MIL-PRF-83536/15
AMENDMENT 4
10 July 1999
SUPERSEDING
AMENDMENT 3
14 August 1998

PERFORMANCE SPECIFICATION SHEET

RELAYS, ELECTROMAGNETIC, ESTABLISHED RELIABILITY, 4PDT, LOW LEVEL TO 10 AMPERES, PERMANENT MAGNET DRIVE, HERMETICALLY SEALED, ALL WELDED, DC COIL

This amendment forms a part of MIL-PRF-83536/15, dated 27 March 1992, and is approved for use by all Departments and Agencies of the Department of Defense.

SOCKET PIN TERMINAL

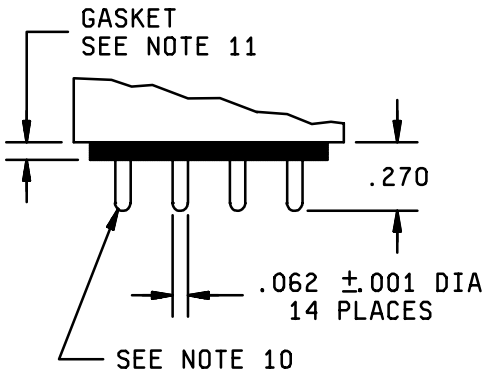
FIGURE 1, socket pin terminal diagram, delete and substitute:
